Uniform provisions concerning the approval of motor vehicles with regard to the Advanced Emergency Braking System (AEBS) for M₂, M₃, N₂ and N₃ vehicles

Industry draft proposals with purple text (AEBS-05)

Industry input for deadline 14 September 2021

Revision 1 – 17 September 2021

Figure 1:
Left turn or right turn at the intersection

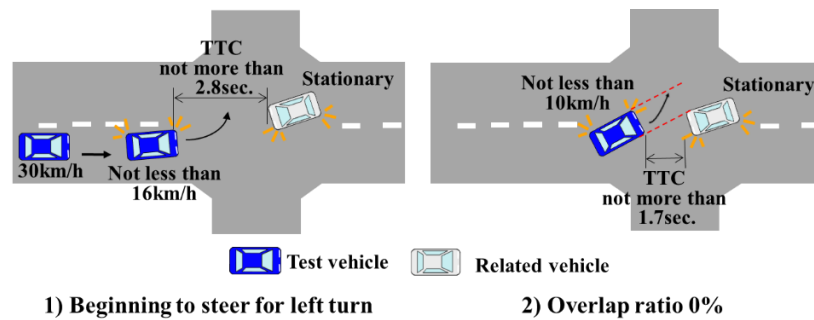
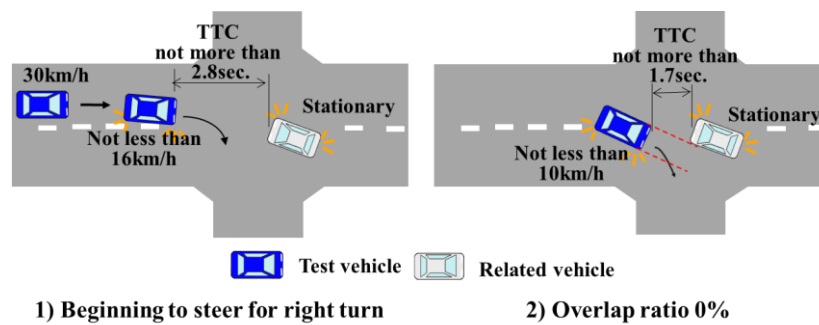
The blue car needs to be changed from passenger vehicle to large vehicle.

Figure 2:
Right turn or left turn of a forward vehicle

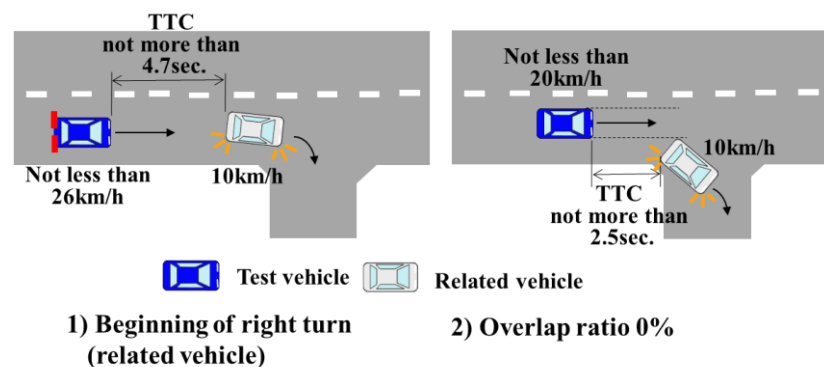
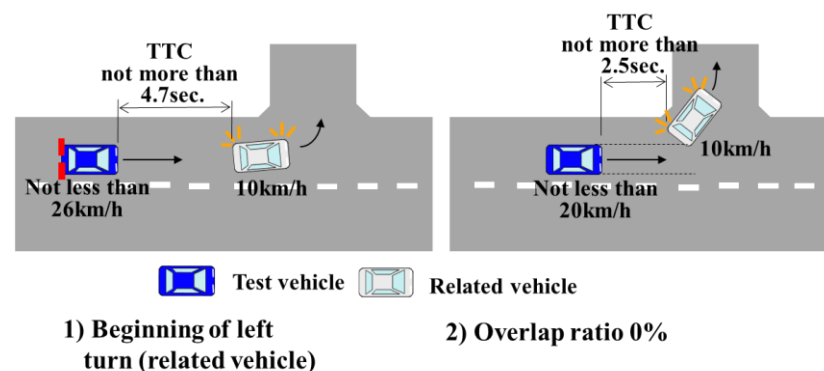
The blue car needs to be changed from passenger vehicle to large vehicle.

Figure 4:
Lane change due to road construction

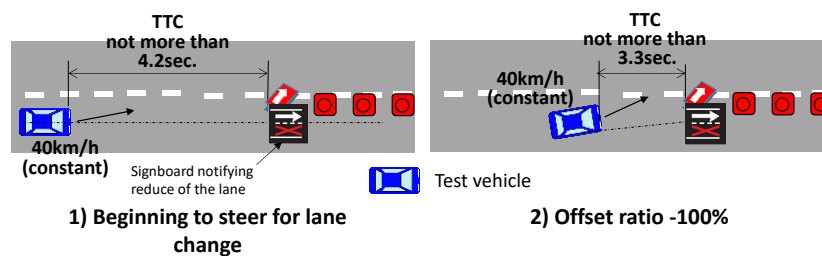
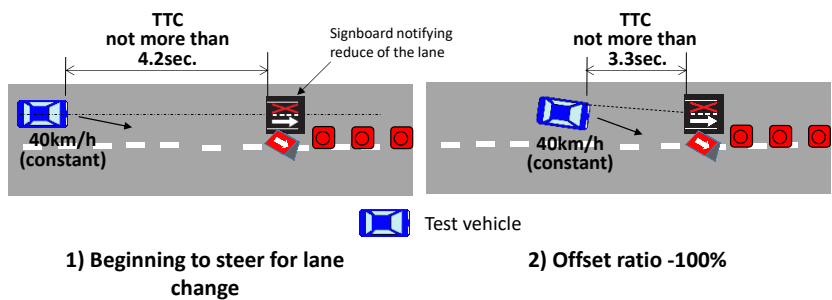
The blue car needs to be changed from passenger vehicle to large vehicle.
